UNITED STATES PATENT AND TRADEMARK OFFICE

APPLICATION NO.	FILING DATE	FIRST NAMED INVENTOR	ATTORNEY DOCKET NO.	CONFIRMATION NO.
10/799,396	03/12/2004	Young-Joon Rhee	AB-1355 US	7324

Office Action Summary

DETAILED ACTION

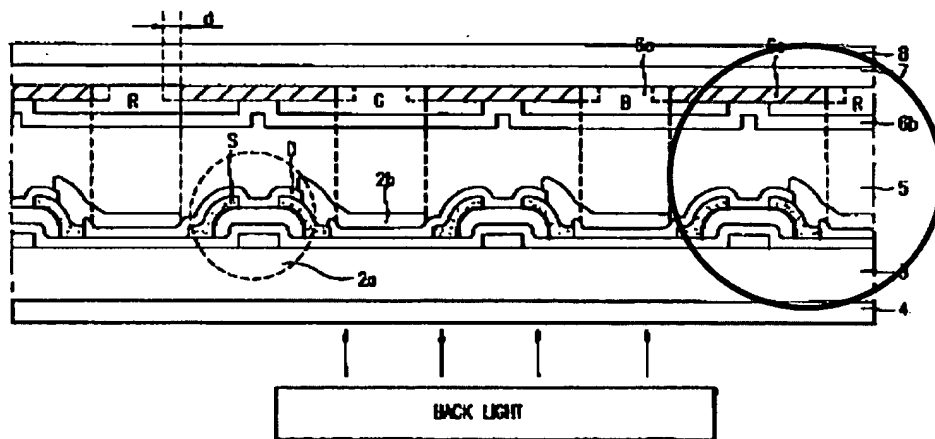
Lyu in Figure 2 discloses the (circled in drawing below) second pixel electrode (2b) formed on the substrate (3) connected to the thin film transistor (2a) and the second pixel electrode do not overlap the other color filters (R,G,B). The second pixel is located on the same layer as all the other color filters. The second pixel electrode is included to add another color filter or white filter.
